Access Compliance Report

Public Rights-of-Way

Intersection ID: 3033	Main Street: DEARMON_RD	Cross Street: BENFIELD_RD	Location:	E
ADA ID: 93E280D30FCF	Ramp Type: Perp	Initial Pass/Fail: Fail	Overall Compliance: No	Severity Score: 26.25

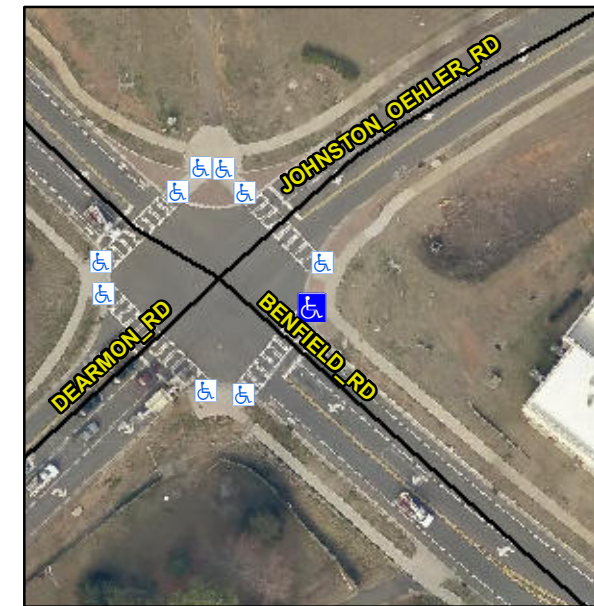
R304.2.2

Compliance	Description	Data	Compliance	Description	Data
N/A	Ramp Length (in)	96.0	No	Ramp Slope (%)	19.3
Yes	Ramp Width (in)	66.5	Yes	Ramp XSlope (%)	4.7
N/A	Flare Type LT	N/A	N/A	Flare Type RT	N/A
N/A	Flare Slope LT (%)	N/A	N/A	Flare Slope RT (%)	N/A
N/A	Flare Traversable LT?	N/A	N/A	Flare Traversable RT?	N/A
N/A	Landing Length (in)	N/A	N/A	DWS Provided?	N/A
N/A	Landing Width (in)	N/A	N/A	DWS Contrast?	N/A
N/A	Landing Slope (%)	N/A	N/A	DWS Length (in)	N/A
N/A	Landing X Slope (%)	N/A	N/A	DWS Full Width?	N/A
N/A	Landing Curb? (Y/N)	N/A	N/A	DWS Offset (in)	N/A
N/A	Shared Landing?	N/A			
N/A	Gutter Ponding?	N/A	N/A	Gutter Slope (%)	N/A
N/A	Gutter Lip Ht (in)	N/A	N/A	Gutter X Slope (%)	N/A
N/A	Painted X Walk1?	Yes	N/A	Painted X Walk2?	N/A
	X Walk 1 Direction	To SW		X Walk 2 Direction	N/A
N/A	X Walk 1 Width (in)	111.0	N/A	X Walk 2 Width (in)	N/A
	X Walk 1 Slope (%)	5.2		X Walk 2 Slope (%)	N/A
	X Walk 1 X Slope (%)	5.6		X Walk 2 X Slope (%)	N/A

Remove & Replace Entire Ramp.
